STATE OF CONNECTICUT
CONNECTICUT SITING COUNCIL

IN RE: :
: :
APPLICATION OF CELLCO PARTNERSHIP : DOCKET NO. 403
D/B/A VERIZON WIRELESS FOR A :
CERTIFICATE OF ENVIRONMENTAL :
COMPATIBILITY AND PUBLIC NEED FOR :
THE CONSTRUCTION, MAINTENANCE :
AND OPERATION OF A WIRELESS :
TELECOMMUNICATIONS FACILITY AT :
174 SOUTH GRAND STREET, SUFFIELD, :
CONNECTICUT : AUGUST 25, 2010

RESPONSES OF CELLCO PARTNERSHIP d/b/a VERIZON WIRELESS TO
CONNECTICUT SITING COUNCIL PRE-HEARING INTERROGATORIES, SET ONE

LPA-80063-6CF-EDIN-X

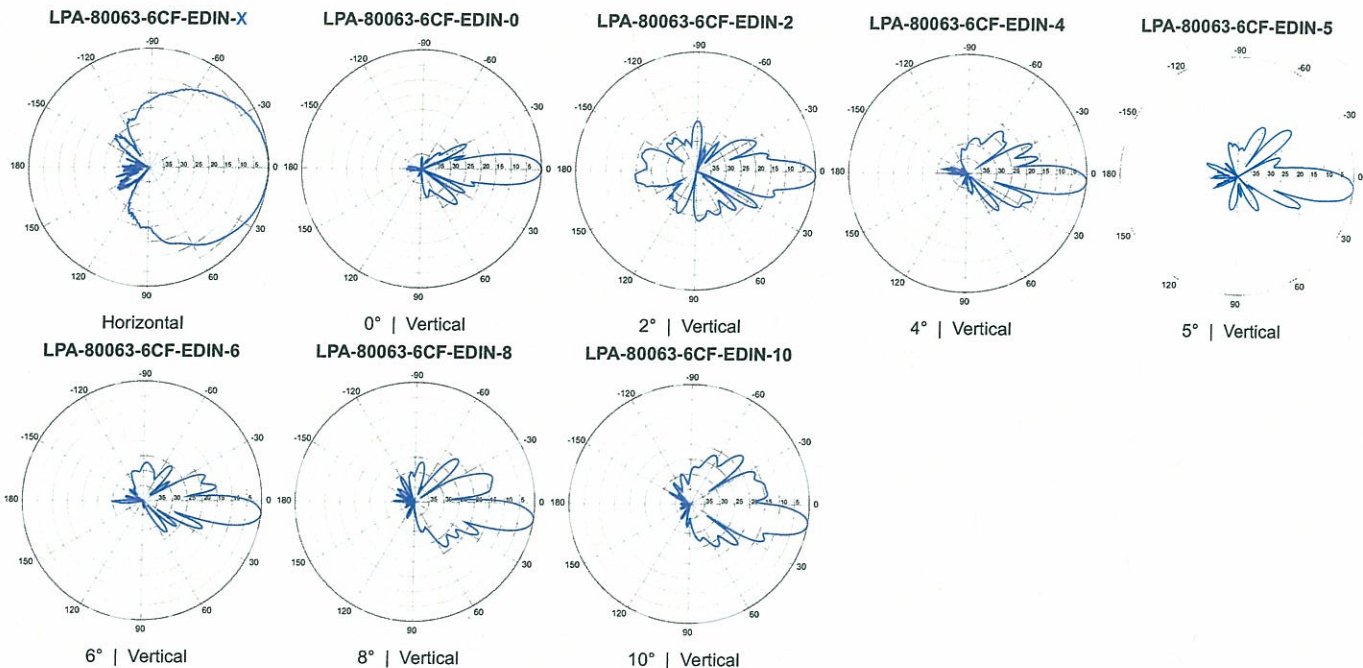
Provide the following information: number of channels per sector for each antenna system that would be installed on the proposed tower, ERP per channel for each antenna system, and frequency at which each antenna system would operate.

Specifications for all but one of the antennas listed above are included behind Tab 7 of the Application. A copy of the Model 80063/6CF antenna specification is attached behind Tab 1 of these responses.

Docket No. 403
Response To Connecticut Siting Council
Pre-Hearing Interrogatory Question #5
Verizon Wireless Cellular Coverage At 110 Feet AGL
Suffield, Connecticut and Surrounding Area
(*Map Scale is 1:30,000)

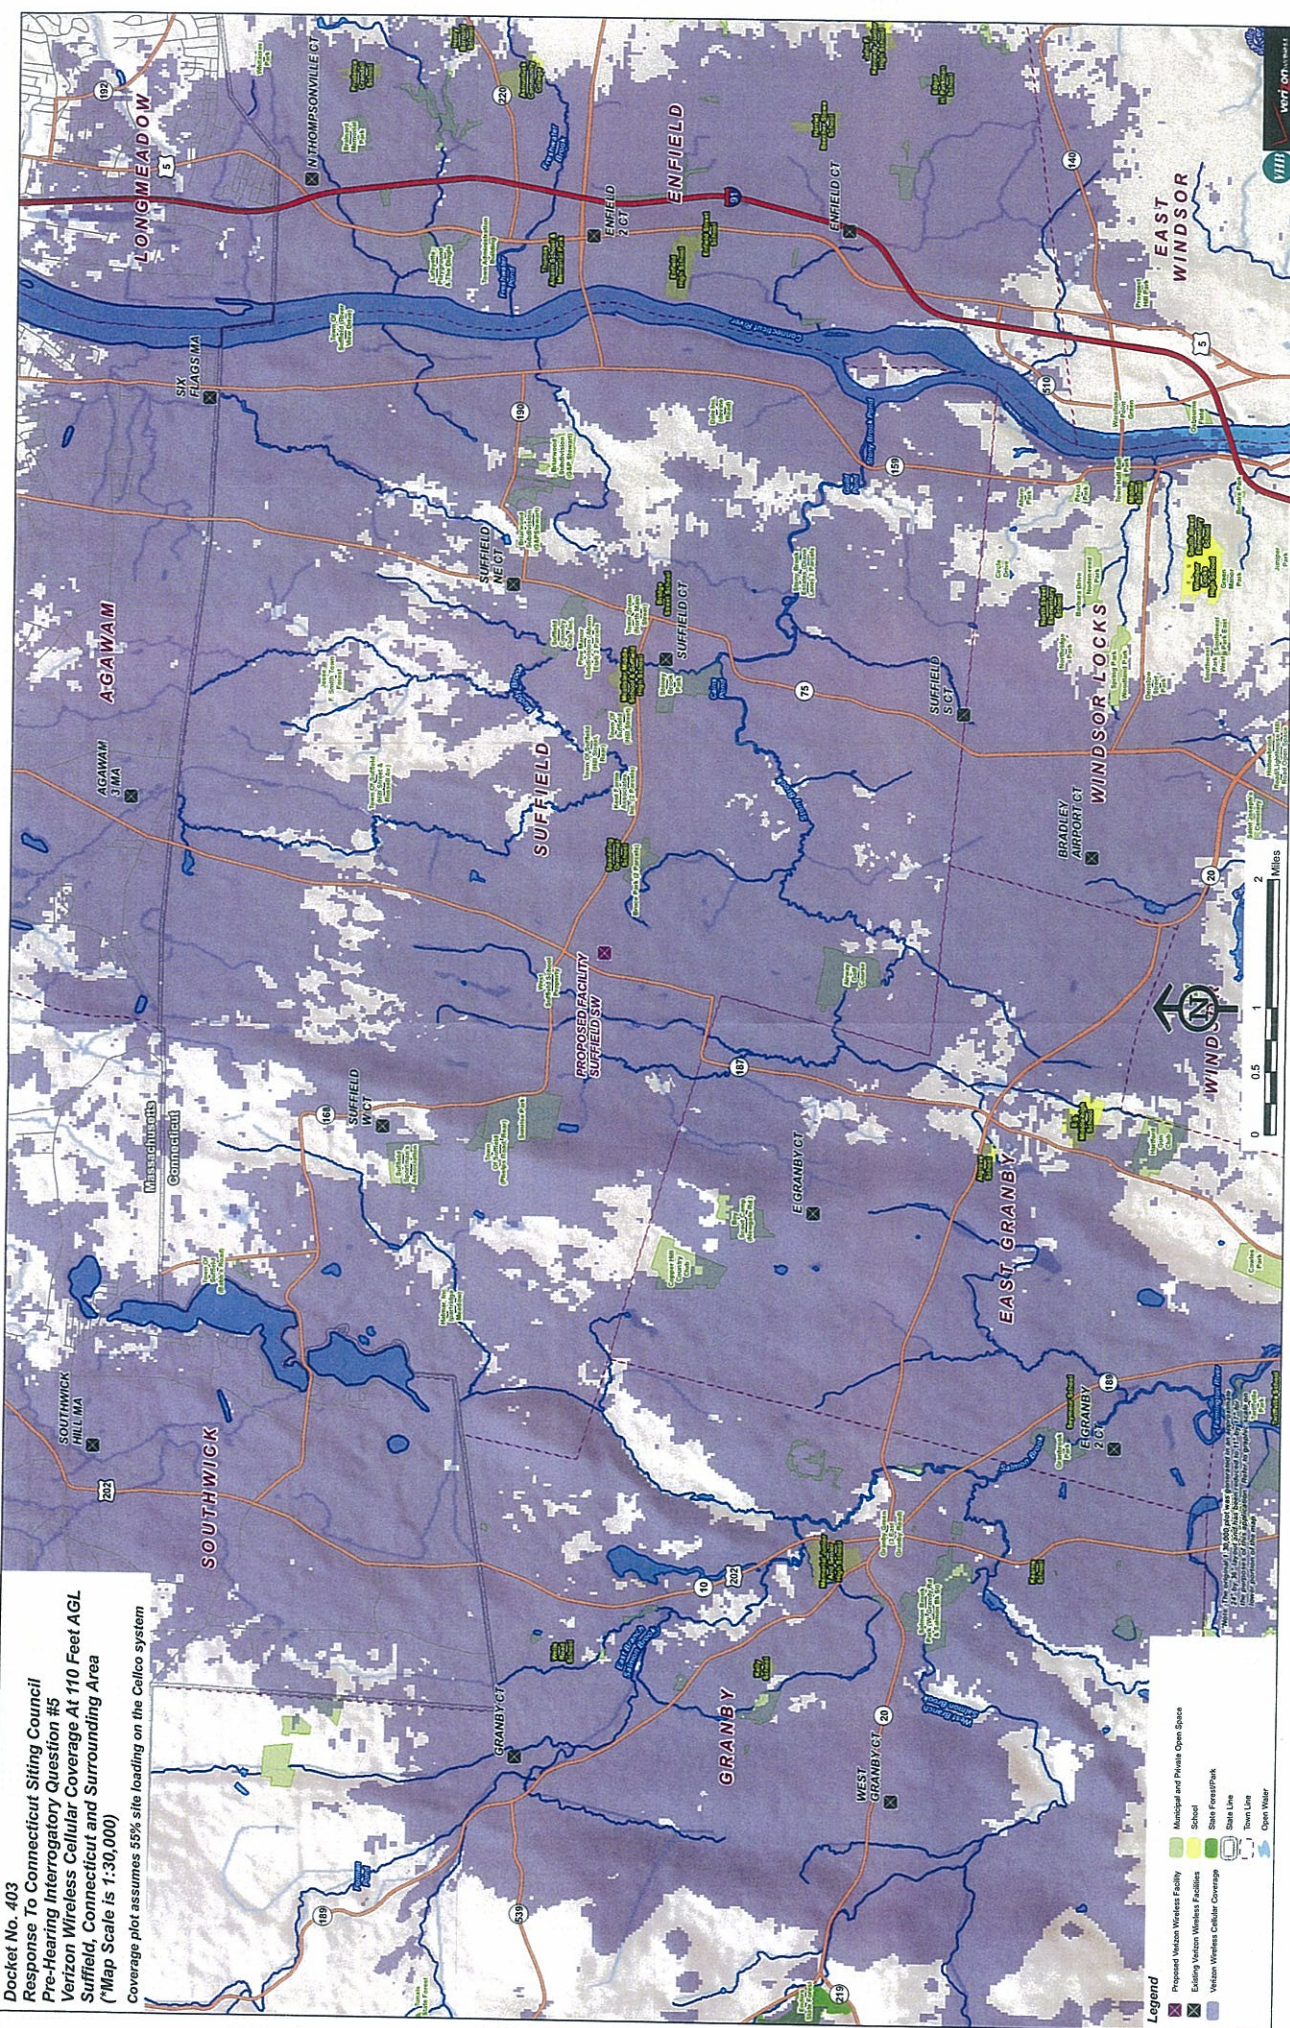
What is the lowest height at which Cellco's antennas could achieve its coverage objectives from this site? Submit propagation maps showing the coverage at ten feet below this height.

Cellco has determined that the 120-foot level is the minimum height need to satisfy it coverage objectives in the area. Plots showing Cellco's coverage at 110 feet are attached behind Tab 2.
